Access Compliance Report

Public Rights-of-Way

(Curb Ramps)

Intersection ID: 9982	Main Street: E_36TH_ST	Cross Street: N_DAVIDSON_ST	Location: S
ADA ID: 4B599E2DF3DA	Ramp Type: PerpDiag	Initial Pass/Fail: Fail	Overall Compliance: No
Severity Score: 12.5			
Codes/Mitigation Info/Possible Solution		Field Measurements/Component Compliance

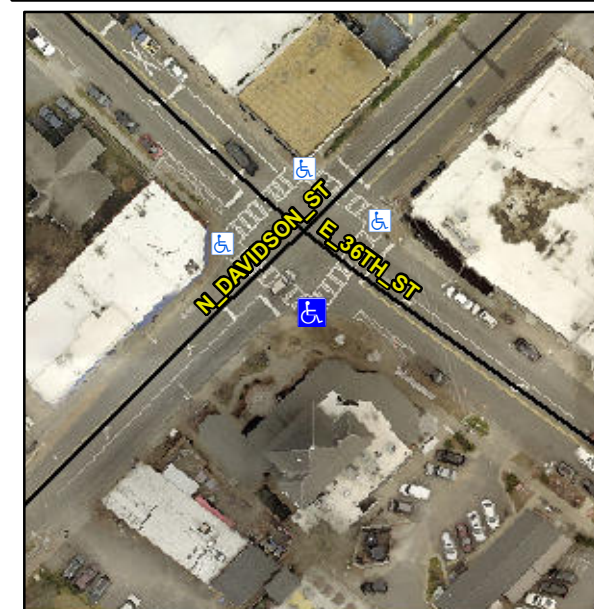
Compliance	Description	Data	Compliance	Description	Data
N/A	Ramp Length (in)	66.0	No	Ramp Slope (%)	9.3
Yes	Ramp Width (in)	48.0	Yes	Ramp XSlope (%)	0.8
N/A	Flare Type LT	N/A	N/A	Flare Type RT	N/A
N/A	Flare Slope LT (%)	N/A	N/A	Flare Slope RT (%)	N/A
N/A	Flare Traversable LT?	N/A	N/A	Flare Traversable RT?	N/A
N/A	Landing Length (in)	N/A	N/A	DWS Provided?	N/A
N/A	Landing Width (in)	N/A	N/A	DWS Contrast?	N/A
N/A	Landing Slope (%)	N/A	N/A	DWS Length (in)	N/A
N/A	Landing X Slope (%)	N/A	N/A	DWS Full Width?	N/A
N/A	Landing Curb? (Y/N)	N/A	N/A	DWS Offset (in)	N/A
N/A	Shared Landing?	N/A			
N/A	Gutter Ponding?	N/A	N/A	Gutter Slope (%)	N/A
N/A	Gutter Lip Ht (in)	1.0	N/A	Gutter X Slope (%)	N/A
N/A	Painted X Walk1?	Yes	N/A	Painted X Walk2?	Yes
	X Walk 1 Direction	To NE		X Walk 2 Direction	To NW
N/A	X Walk 1 Width (in)	110.0	N/A	X Walk 2 Width (in)	108.0
	X Walk 1 Slope (%)	4.5		X Walk 2 Slope (%)	3.2
	X Walk 1 X Slope (%)	1.4		X Walk 2 X Slope (%)	2.3

Remove & Replace Curb Ramp With Two New Directional Ramps or Equivalent.
